ADDENDUM NO. 1

LOWER POPLAR WATER RECLAMATION FACILITY INFLUENT PUMP STATION IMPROVEMENTS

MACON WATER AUTHORITY MACON, GEORGIA

QUESTIONS AND RESPONSES NO. 1

5 PIPE SUPPORT - VERTICAL PIPE CLAMP
SCALE: N.T.S.

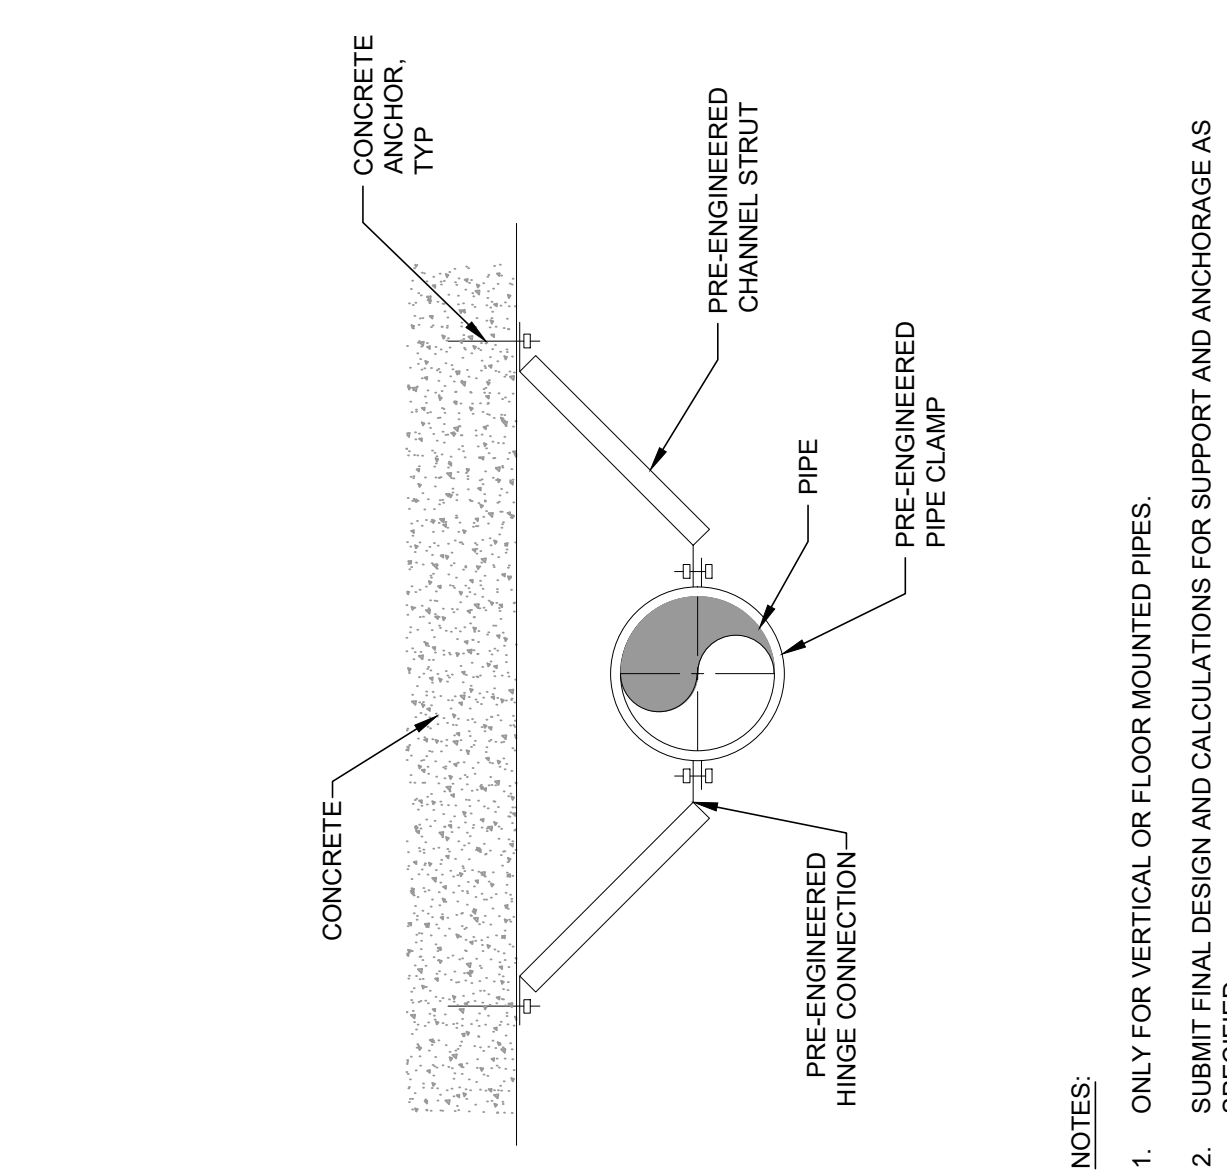
10.	Q:	Please clarify pipe support detail on Sheet 09-D103 is adjustable or non adjustable. D103
	R:	Adjustable – See Addendum No. 1

Delete Drawing 99-D501 and replace with Drawing 99-D501 attached.
